# Product Change Notification

## 113286 - 00

**Change Notification #:** 113286 - 00  
**Change Title:** Intel® Server System R2308GZ4GC  
PCN 113286-00, Product Design  
Update the System Rear Panel, 750W Common  
Redundant Power Supply and  
BIOS/ME/BMC/FRUSDR Firmware  
**Date of Publication:** October 13, 2014

Figure One

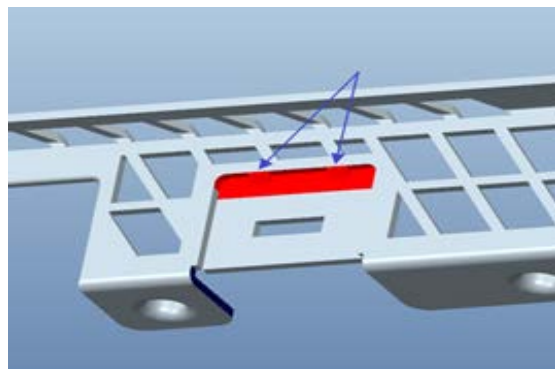
1. Update the one big center joint to two smaller joints so that the joints will not conflict with the LAN cable connector latch. See the Figure One.

Figure Two

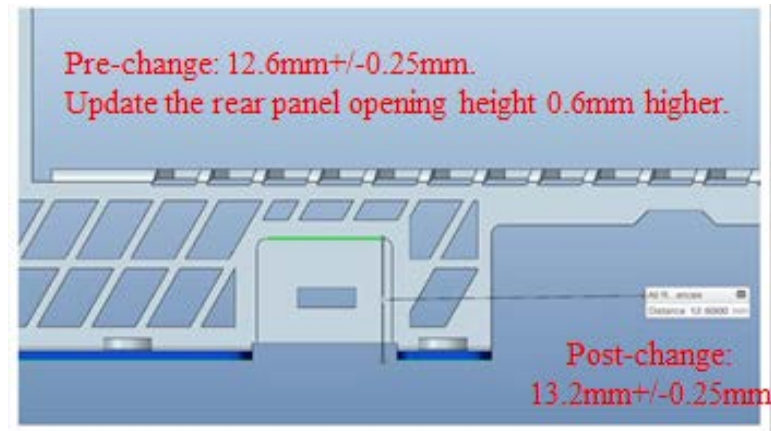
2. Update the rear panel opening height 0.6mm higher to improve the flexibility for the cable latch. The previous height was 12.6mm $\pm$ 0.25mm. The updated height is 13.2mm $\pm$ 0.25mm. See the Figure Two.

Figure Three

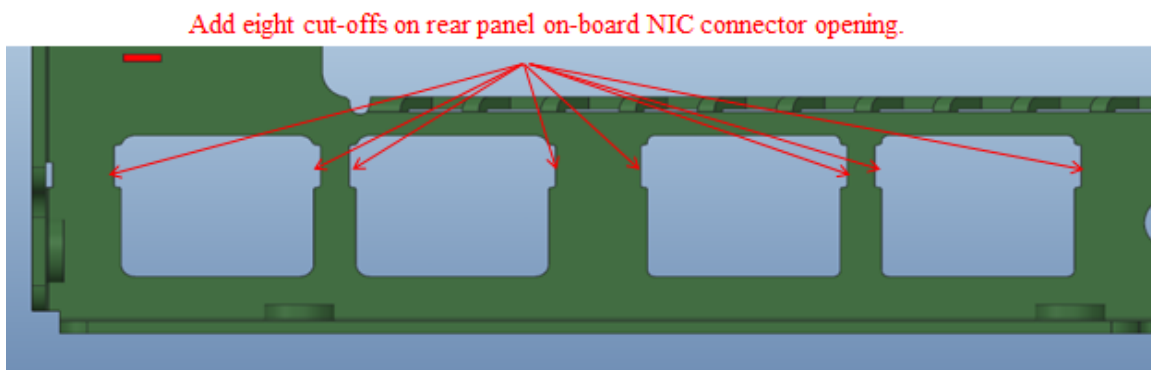
3. Add eight cut-offs around the on-board NIC (Network Interface Controller) openings to improve the LED visibility. See the Figure Three.
